**Memorandum
 Planning and Urban Development Department
 Planning Division**

To: Stuart O’Brien, Chair and Members of the Portland Planning Board
 From: Jean Fraser, Planner
 Date: May 15th, 2015
 Re: Neighborhood Center and Preschool/Daycare
 1342 Congress Street
 Site Plan and Conditional Use(s)
 Jewish Community Alliance of Southern Maine, Applicant
 Project #: 2015-058 CBL: 191 B016001
 Meeting Date: May 19th, 2015

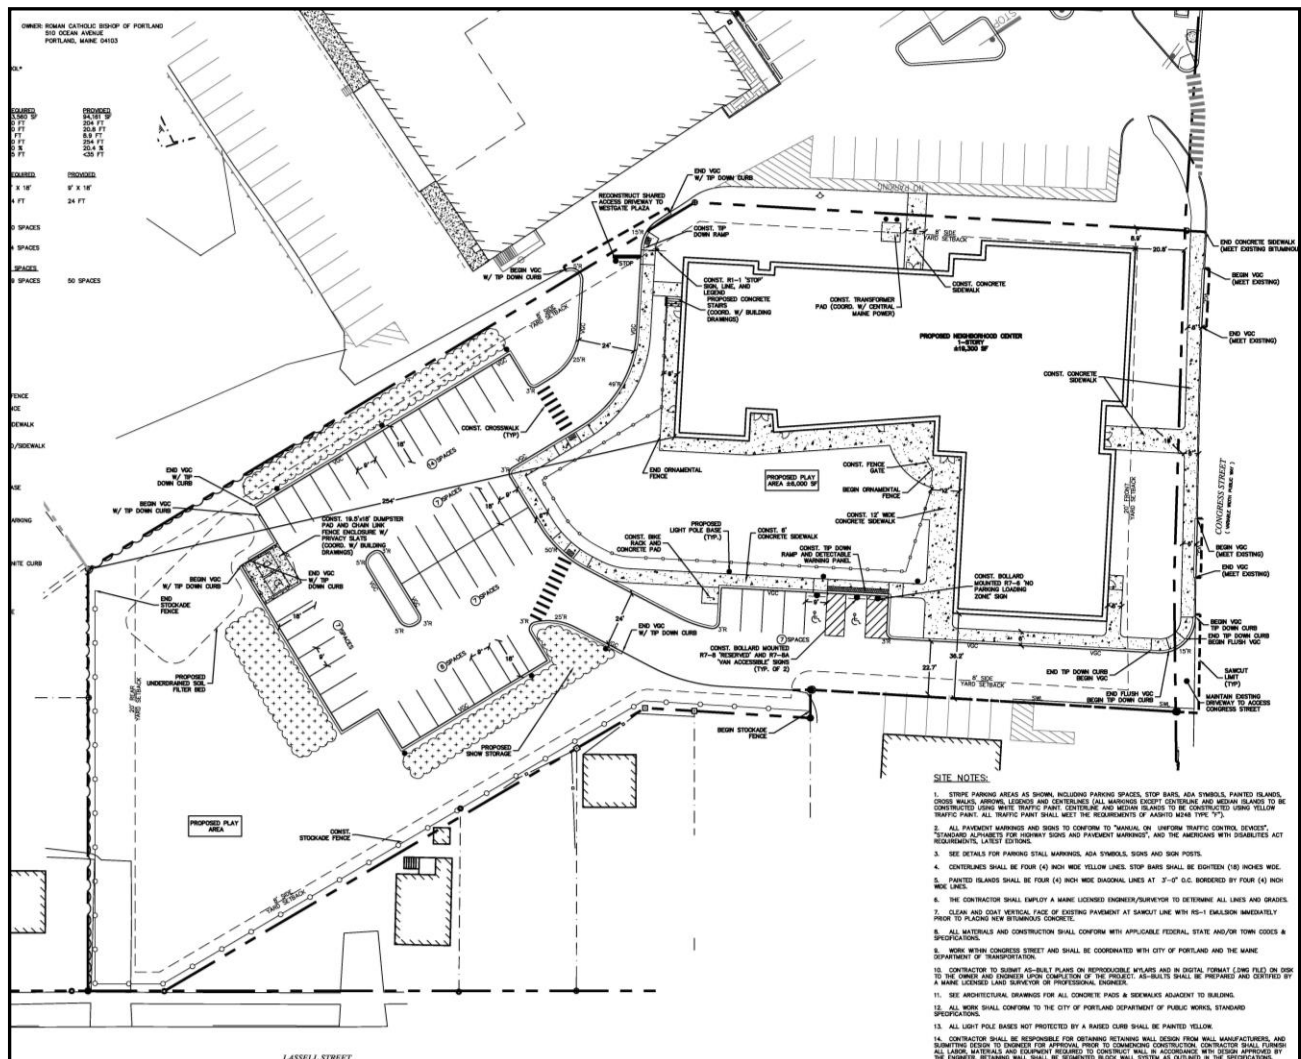
The upper elevation shown right (and in Plan P12) is the proposed new building as viewed from Congress Street; the lower is as viewed from the east (dental offices) and shows the rear day care “wing”.
